CS Memorandum No. 1430

**Subject:** Configuration Management Board Meeting No. 123

## CMB Meeting Minutes #123

1. **1252 – COR 079 – Comp Grout – Old Navy - Update** (previously presented as at CMB mtg #118)
2. **Trend/Change Log – 04/24/13**
3. **Other Business –**

CONTRACT NO.	1252
SFMTA CONTRACT NO.	
DRAWING NO.	UE-127
SHEET NO.

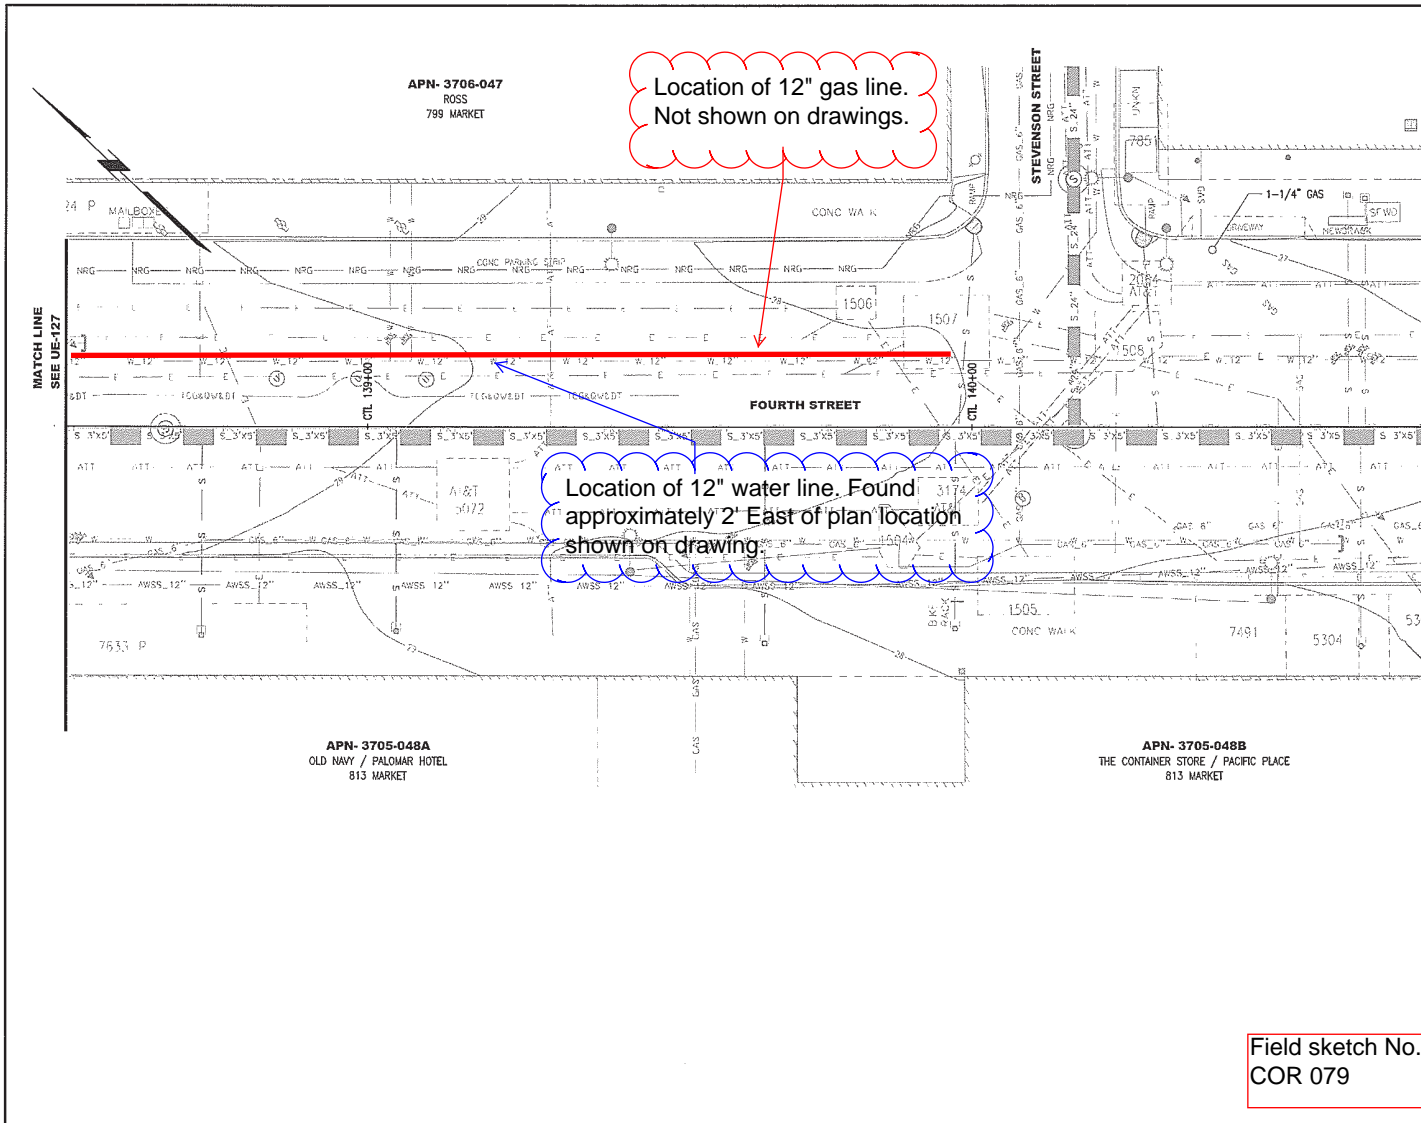
After further field investigation with PG&E and additional potholing efforts, it was determined that there was not sufficient room between existing utilities (known and unknown) to drill the compensation grout holes as designed. The Contractor was able to remove many of these obstructions in an effort to identify a clear window of space in which to locate the proximal points of the compensation grout pipe array. However, one of the obstructions consisted of what was originally believed to be a live 12" waterline which would have caused the proximal points to shift to the east to avoid the live utility. On 4/4/13, it was discovered that this utility was not actually the 12" live waterline and on 4/5/13, PG&E confirmed that the utility was actually a 12" abandoned gas line.

Sketches 045 through 047. However, the Contract Documents, specifically the Utility Demolition and Utility Composite drawings, do not show whether the 12” gas line is live or needs to be removed.

**Recommendation:** Accept justification of Merit for COR 079 – (Comp Grout – Old Navy) - DSC / Design Modifications. There is no time extension recommended for this work.
